## Technical Committee on Liquefied Natural Gas

### NFPA 59A FIRST DRAFT MEETING AGENDA

## Public Input No. 18-NFPA 59A-2019 [ Global Input ]

Figure 11.9.2(a) Dike Height Less Than Distance from Container to Dike ( $H < x$ ).

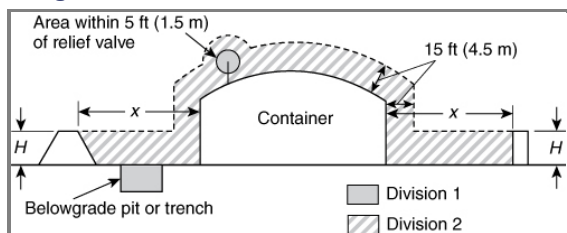
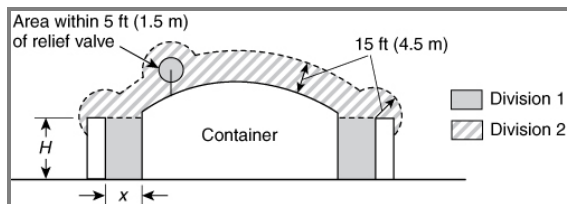
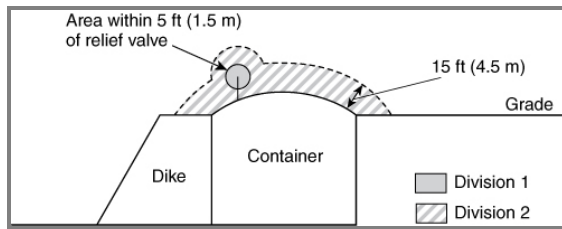
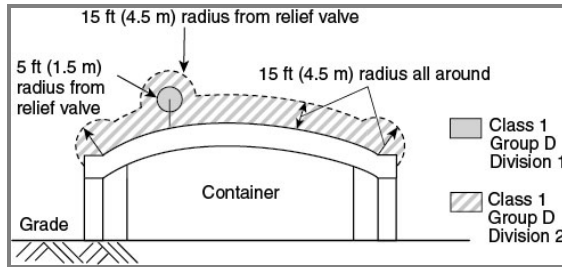
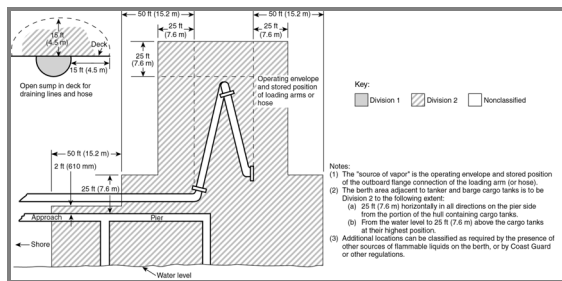
I know there was some clean up on the electrical drawings in the past revision, but I think NFPA 497 provides more detail and guidance for determining electrical area classification for many other situations not defined in NFPA 59A.

Fixed electrical equipment and wiring installed within the classified areas specified in Table 11.9.2 shall comply with Table 11.9.2 and Figure 11.9.2(a) through Figure 11.9.2(e) and shall be installed in accordance with *NFPA 70*.
